**Item 4.****Development Application: 1 Woolley Street, Glebe - D/2019/1416****File No.:** D/2019/1416**Summary****Date of Submission:** 11 December 2019**Applicant:** Fuse Architecture**Architect:** Fuse Architecture**Owner:** Weston Aluminium Pty Ltd**Cost of Works:** \$601,651**Zoning:** R1 General Residential. Residential flat buildings are a permissible use within the zone.**Proposal Summary:** The development application is for the alterations and additions to the existing three storey residential flat building that contains six x two bedroom apartments and a rear outbuilding containing five car spaces and a laundry room.

**Figure 13:** Proposed west elevation

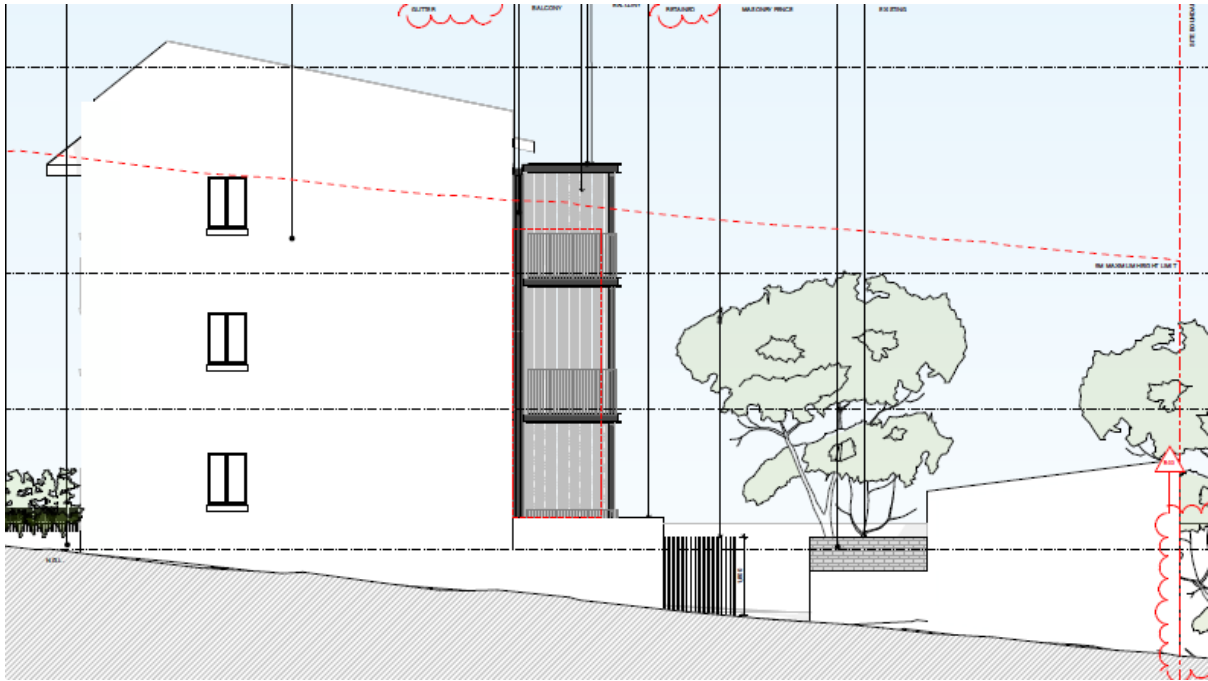
30. As shown in figure 6 and the drawings, the proposed balconies are setback approximately 12.5 metres from the rear yard of 177 Bridge Road, and the view to the west is screened by the rear outbuilding on the subject site and the neighbouring trees. Furthermore, fixed screens of full height of 2.4m are proposed to various parts of the western edge of the balconies to restrict some views to the west and vice versa.

31. As shown in figure 7 and the drawings, the rear yard of 173 Bridge is a car parking lot and the view of the rear yards and windows of 175 Bridge Road are screened by neighbouring trees. Furthermore, a privacy screen is proposed to the full height and width of the southern edge of the balconies to inhibit the views to the south and vice versa.

**Figure 16:** 9m height control shown in red line dashed and existing height of the external stair case shown in red outlined box.

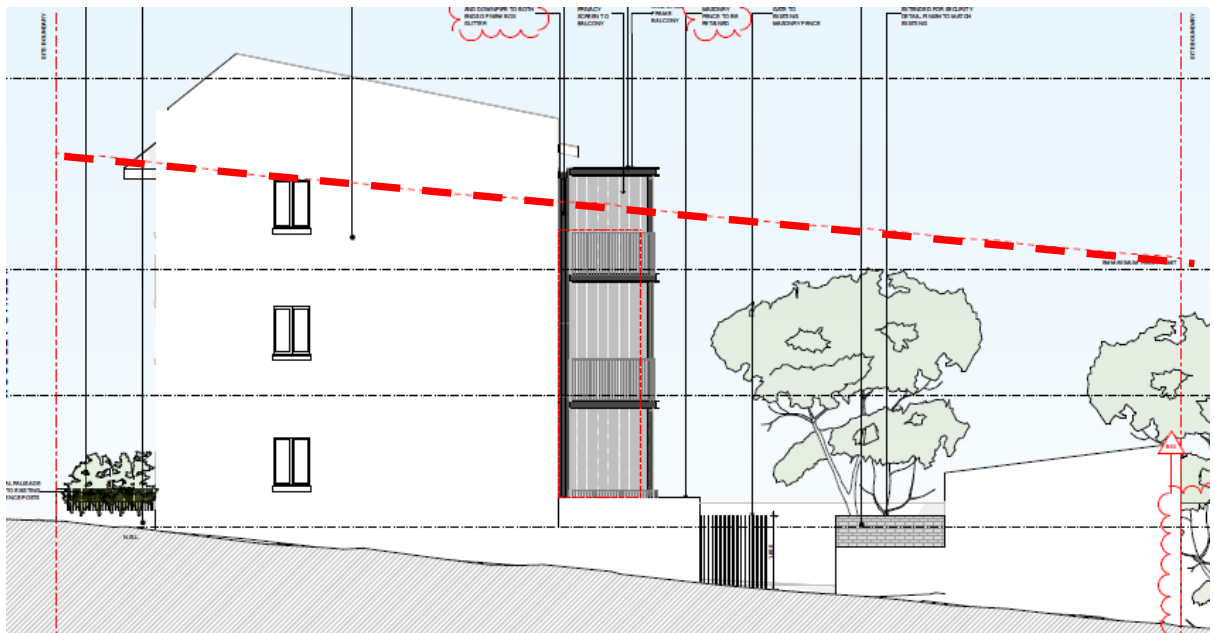
Built Form	Height control	Proposal	Existing Height	Variation of control
Rear Balconies	9m	10.12m	11.5m (ridge height of building)  8.4m (external stair case)	1.12m, 12% variation

- (i) The exceedance of the upper floor balcony, window and sliding doors is due to the existing building being over the existing height control. The proposed works are an appropriate height, bulk and scale to the existing building;
